SAN FRANCISCO PLANNING DEPARTMENT

Executive Summary Amendments to Design-for-Development

Date: October 17, 2019
Case No.: 2007.0946CWP-03
Project Address: **Candlestick Point**
Zoning: Candlestick Point Activity Node Special Use District
Location: *Candlestick Point*
Project Sponsor: Kofi Bonner
FivePoint
1 Sansome, Suite 3200
San Francisco, CA 94104
Staff Contact: Mat Snyder – (415) 575-6891
Mathew.snyder@sfgov.org

REVISIONS OCTOBER 2019

Figure 3.2 Candlestick Illustrative Site Plan

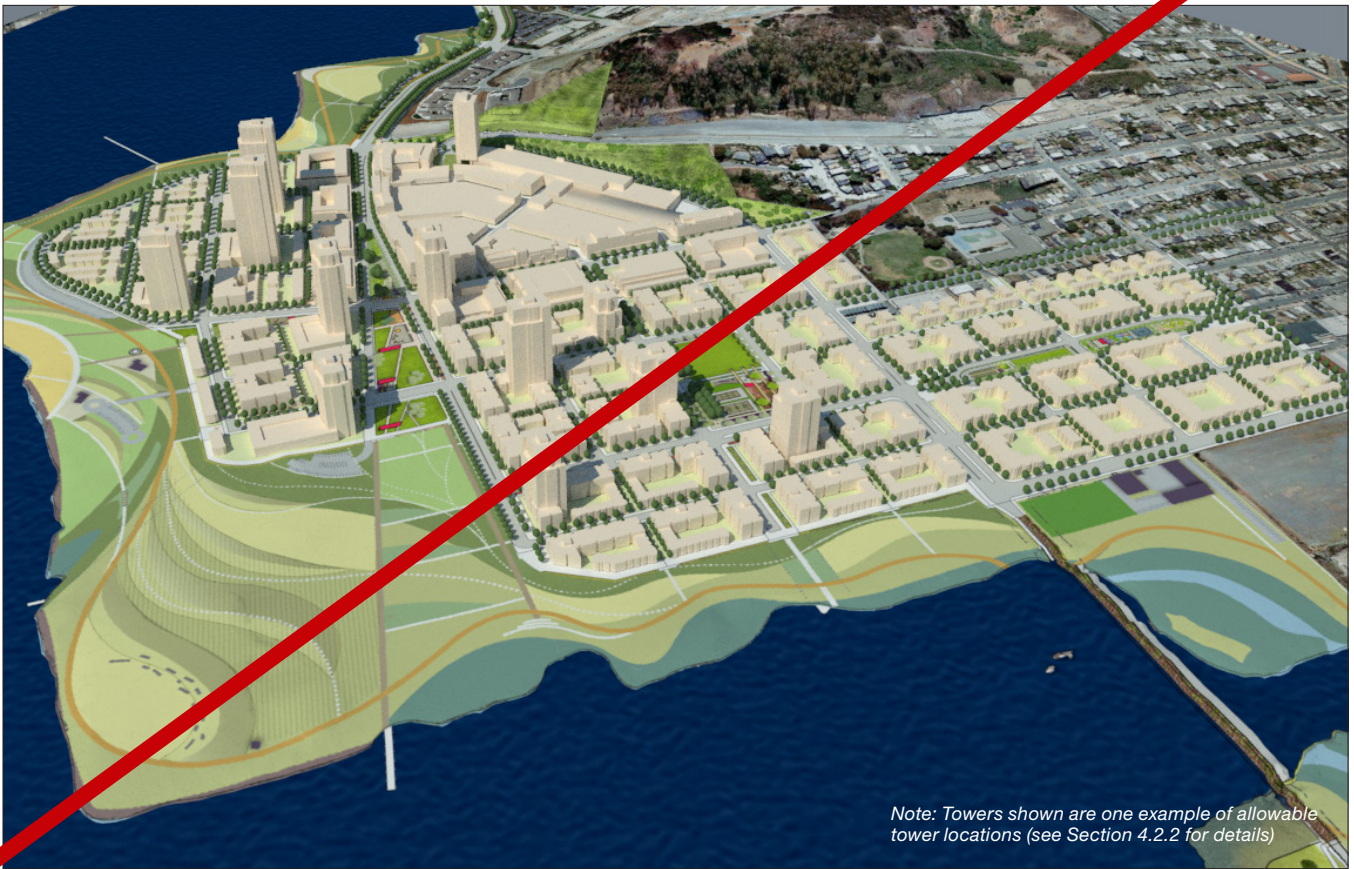
FIGURE 3.2 REVISED - PREVIOUS CANDLESTICK CENTER STREET NETWORK REPLACED AND ADDED NOTE

1. Refer to Section 5.3 (including Figure 5.6) for information regarding Candlestick Center.
2. Towers shown are one example of allowable tower locations (see Section 4.2.2 for details).

Figure 3.3 Public Streets Network

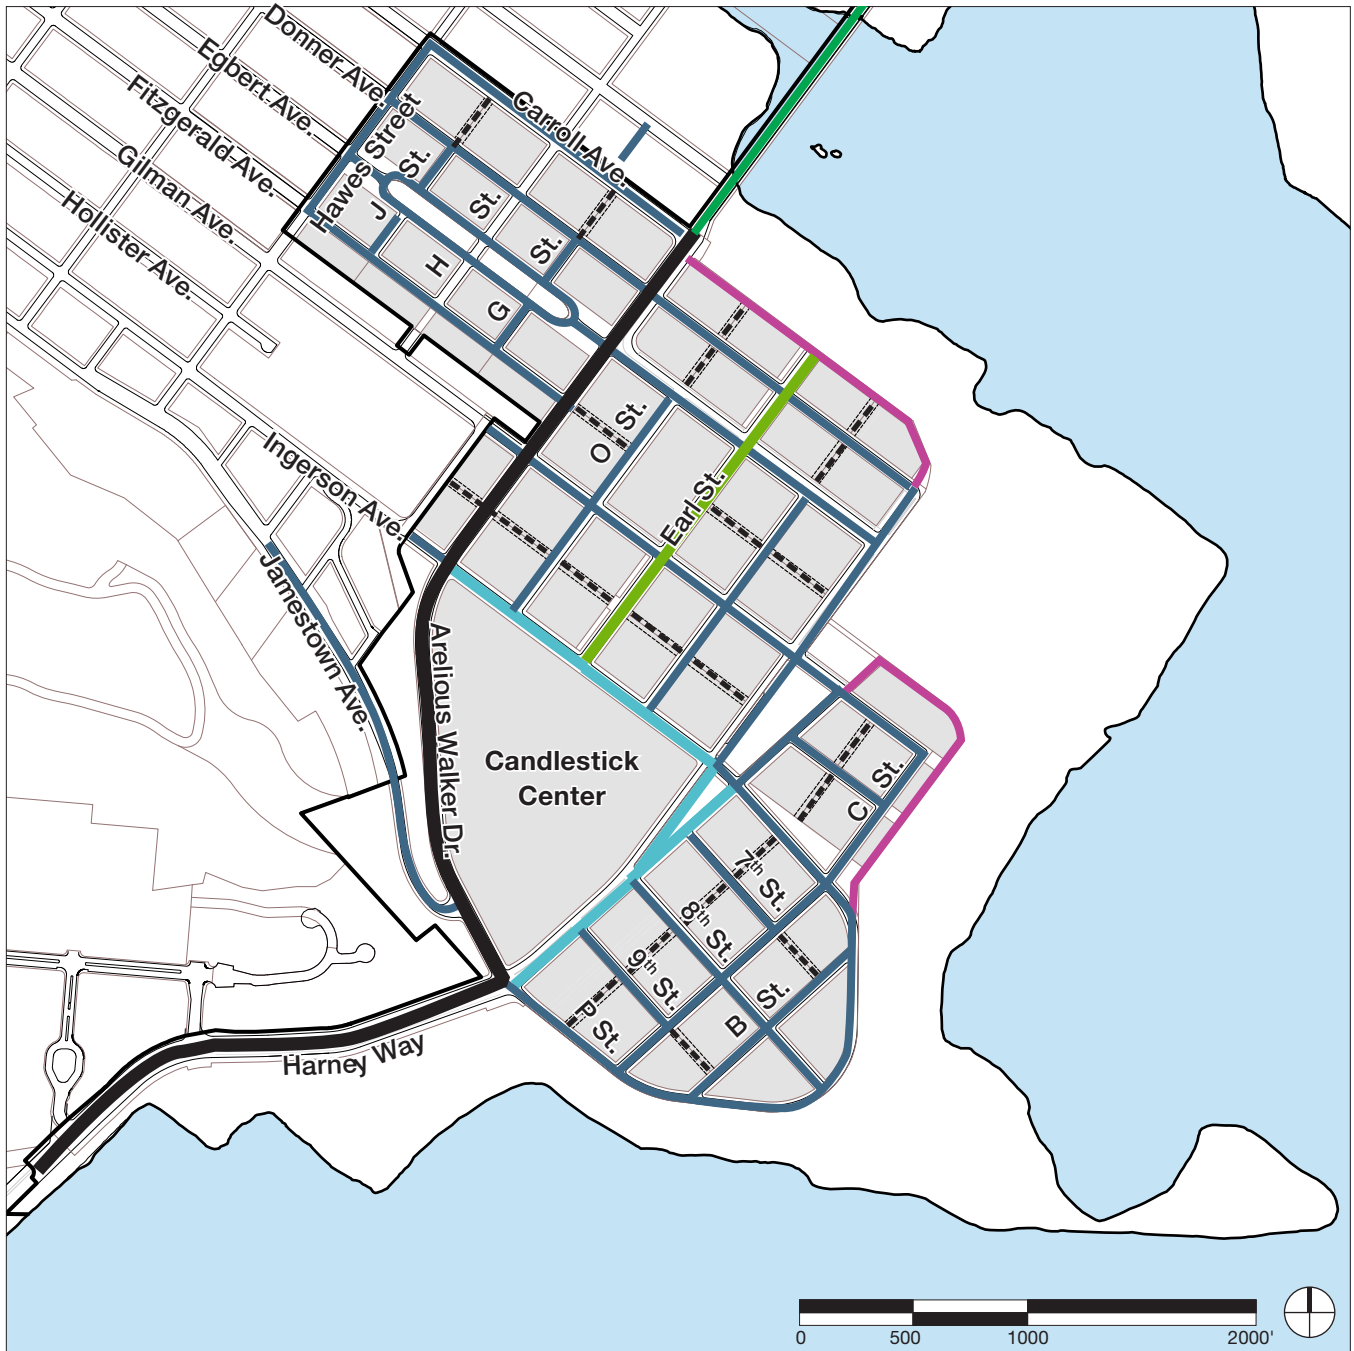
**FIGURE 3.3 IS REPLACED- PREVIOUS CANDLESTICK CENTER STREET NETWORK
REPLACED AND ADDED NOTE**

Figure 4.3 Building Heights

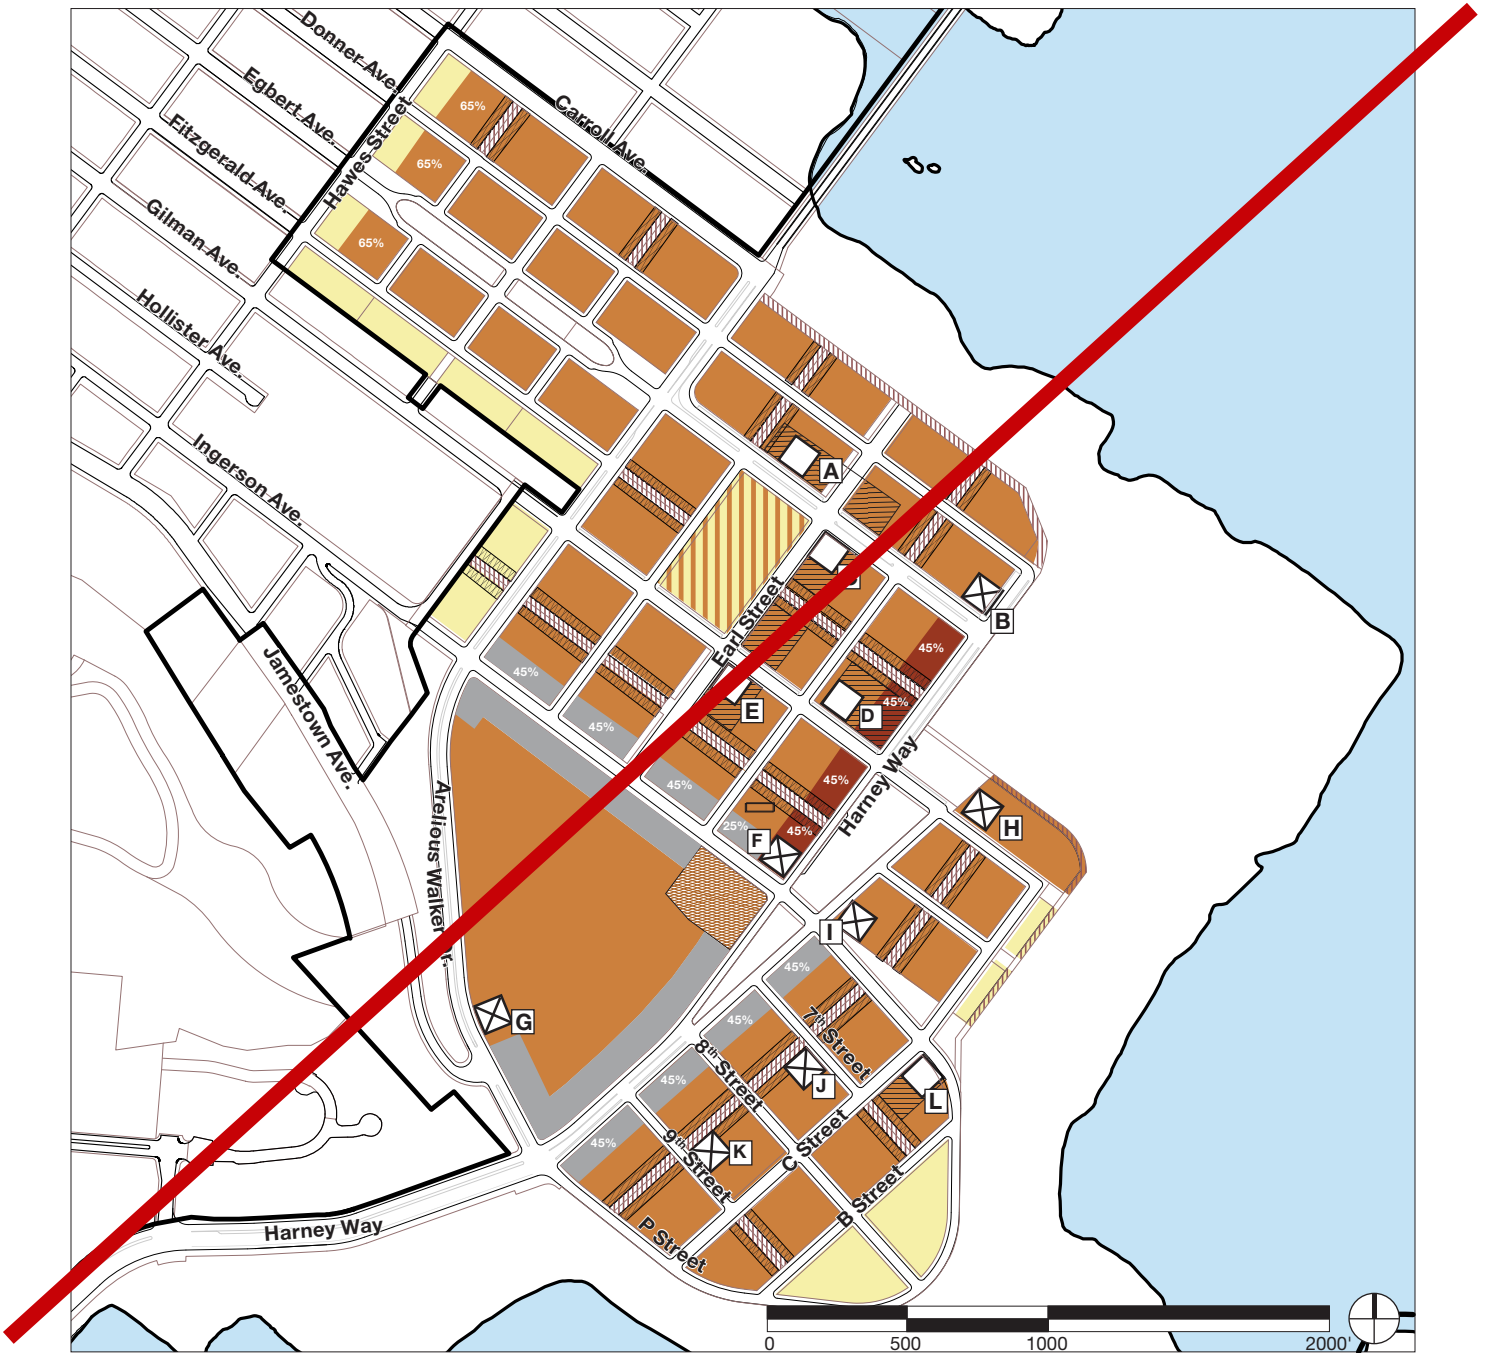
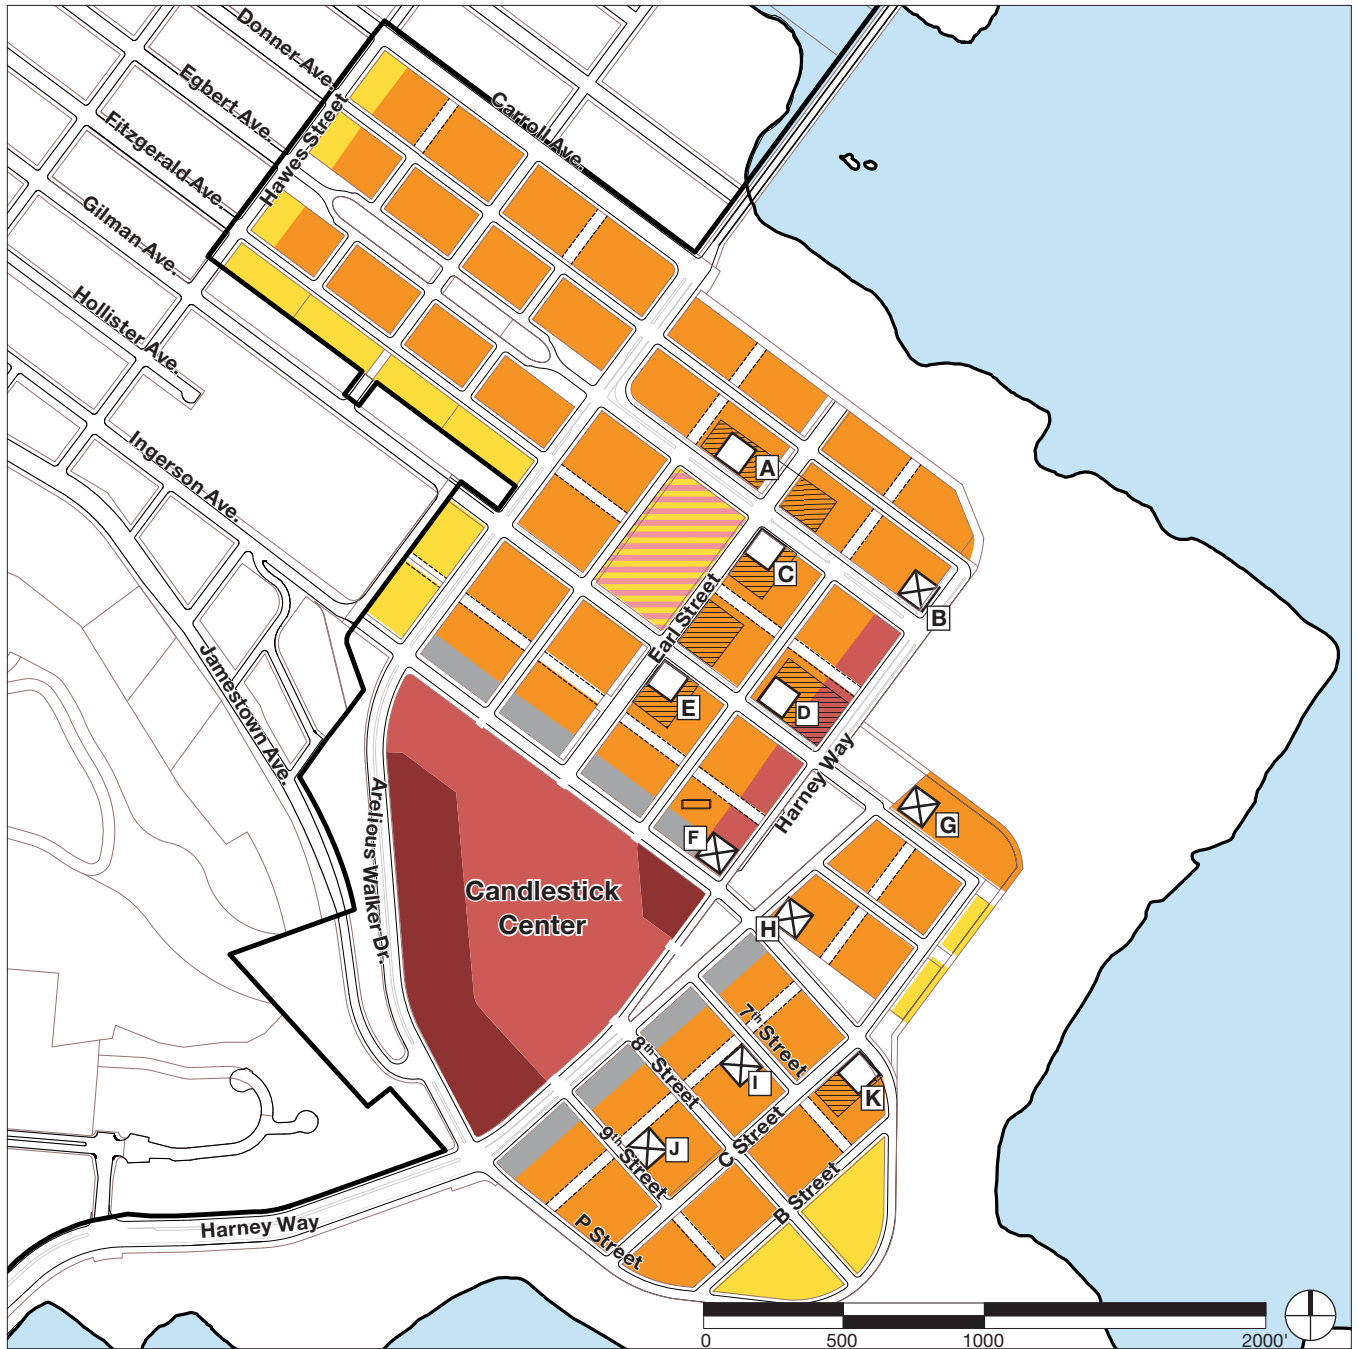
FIGURE 4.3 IS REPLACED. SEE NEXT PAGE.

REVISED FIGURE 4.3

Figure 4.4 Street Wall Conditions

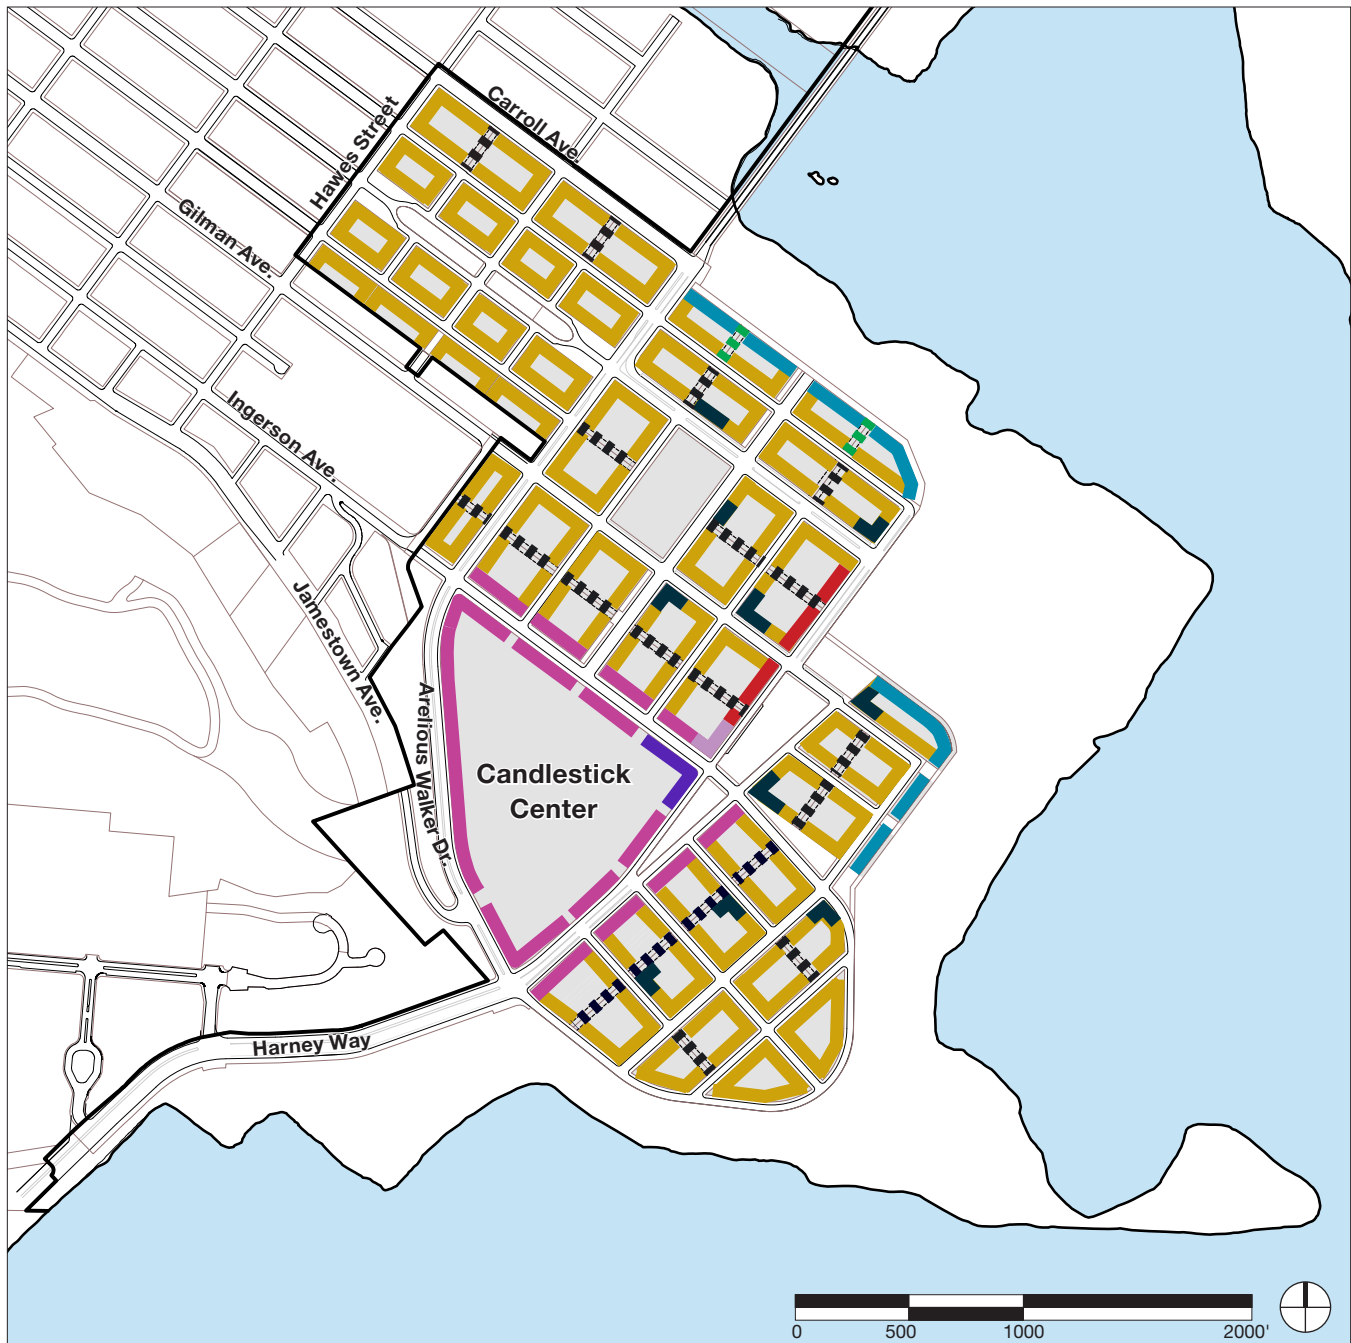
FIGURE 4.4 IS REPLACED. SEE NEXT PAGE.

REVISED FIGURE 4.4

Figure 4.8 D. Mid-rise – Candlestick Center Frame

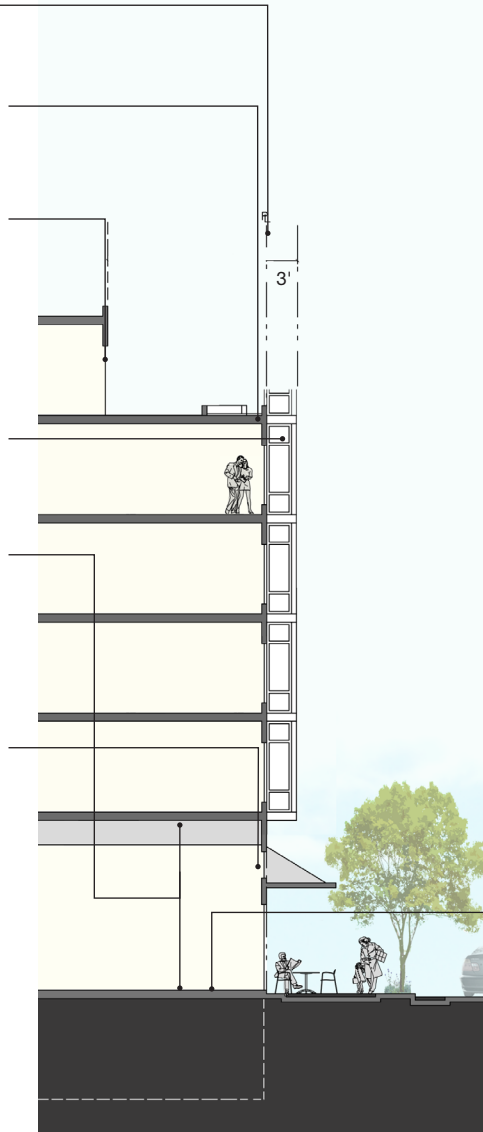
REVISED FIGURE 4.8 AND REVISED TEXT AND PAGE FORMATTING

STEPBACK – Building footprint shall step back 20% in size above 65 ft, **except in Candlestick Center** (see Table 4.4. and 4.6).

Figure 5.1 Character Neighborhoods

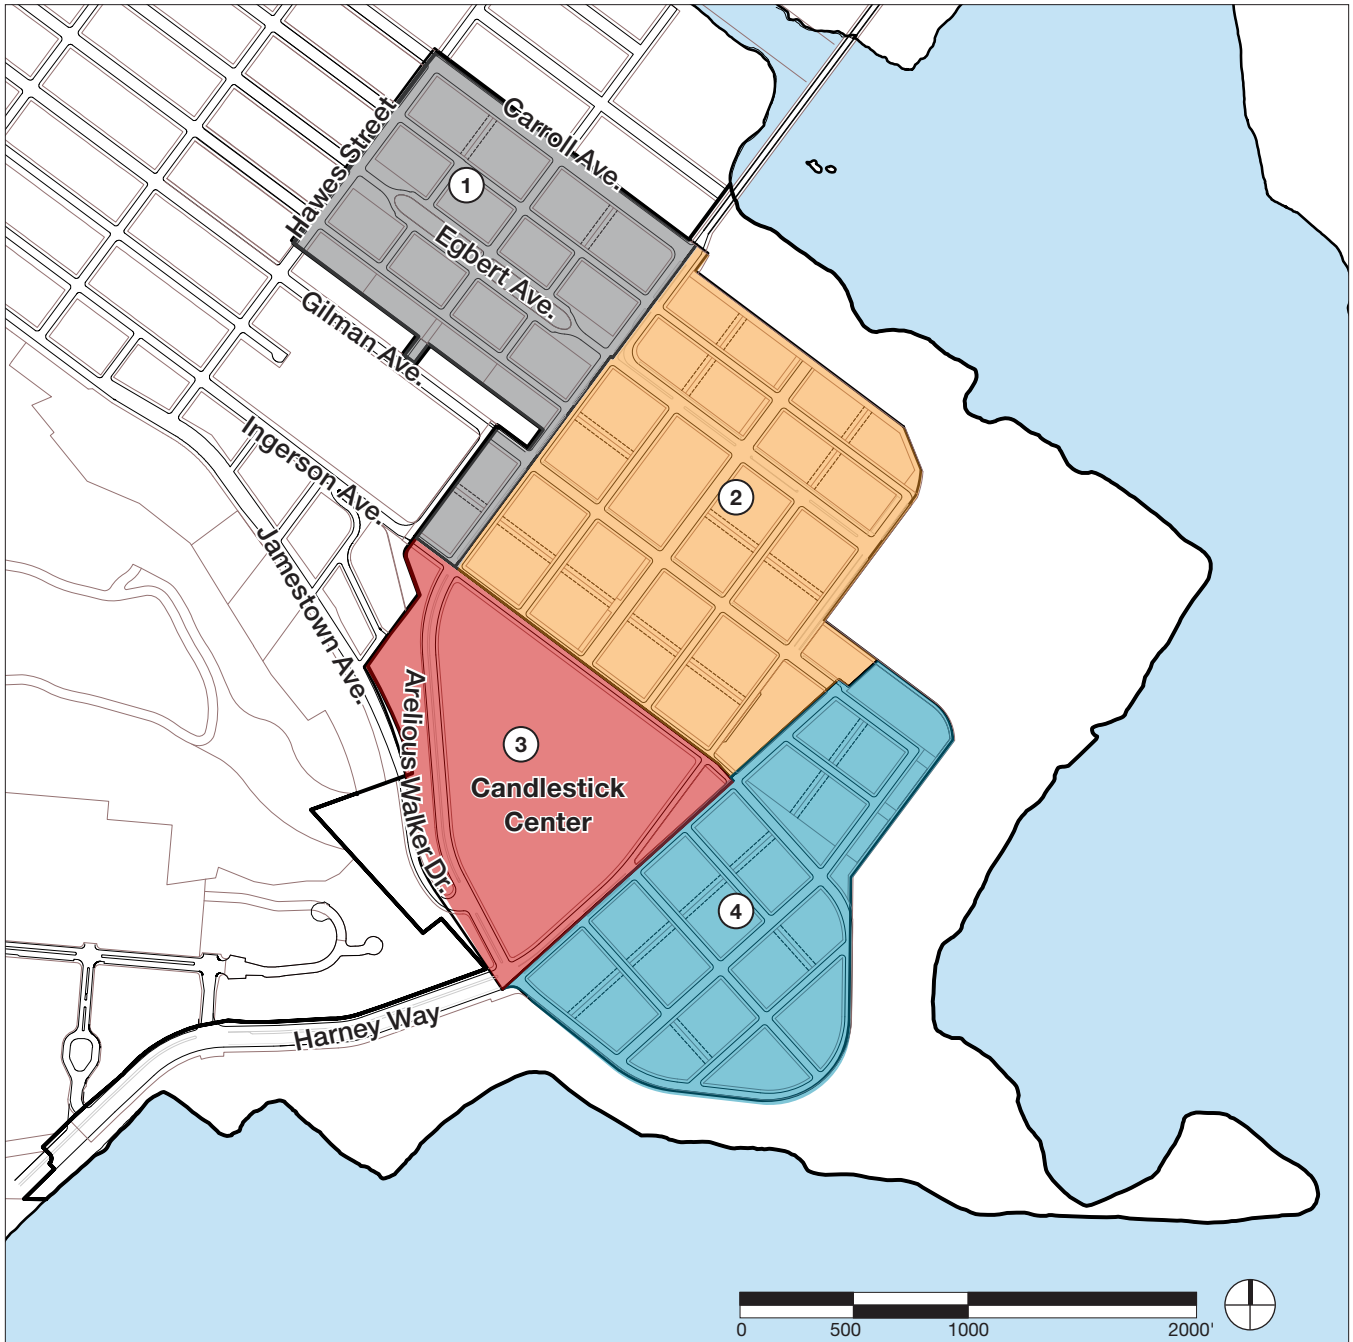
FIGURE 5.1 IS REVISED- JAMESTOWN REMOVED AND ADDED LABEL "CANDLESTICK CENTER"
